This meeting of the Grimes Planning and Zoning Commission was called to order of Tuesday June 4, 2019 at 5:30 P.M. at Grimes City Hall.

O'Reilly Auto Parts – Site Plan

FOX Engineering & City Staff have completed the third review for the O'Reilly Auto Parts Site Plan dated June 12, 2019 and Storm Water Management Plan dated June 26, 2019 and offer the following comments:

RE: Dallas Center - Grimes Administration Building – Site Plan & Preliminary Plat

PROJECT: NEW O'REILLY AUTO PARTS STORE
 EAST 1ST STREET
 GRIMES, IA
 LANDSCAPE PLAN

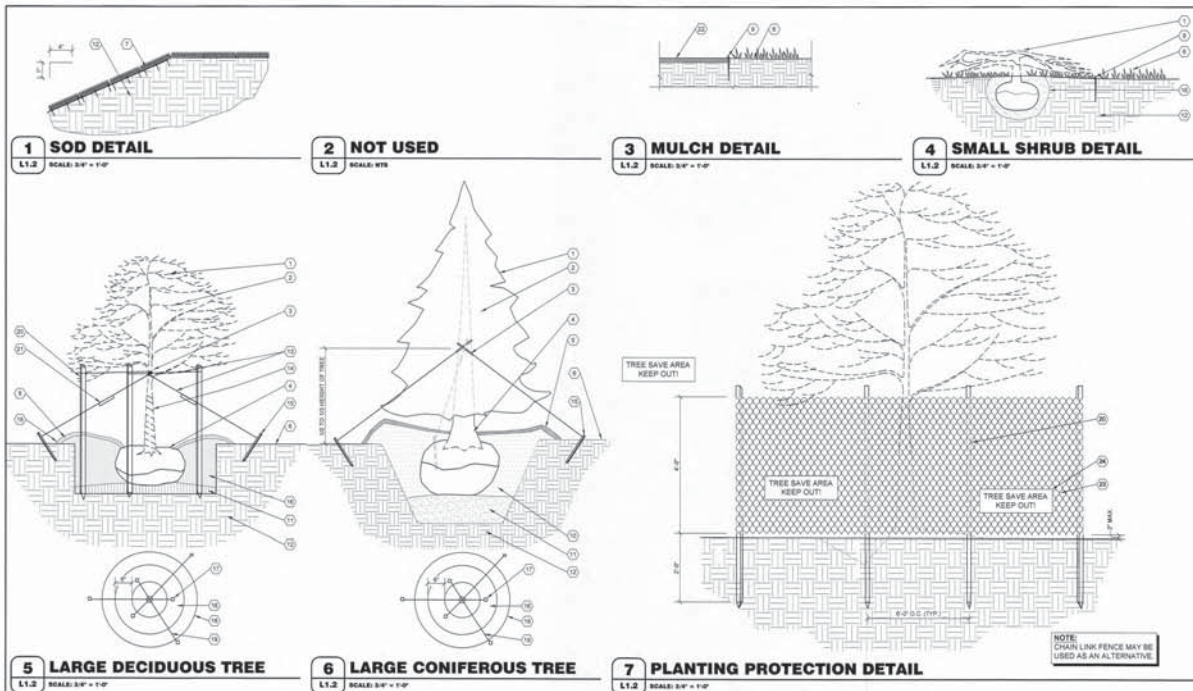
4. The plantings shown on this sheet do not match what is on sheet L1.1. Please revise.
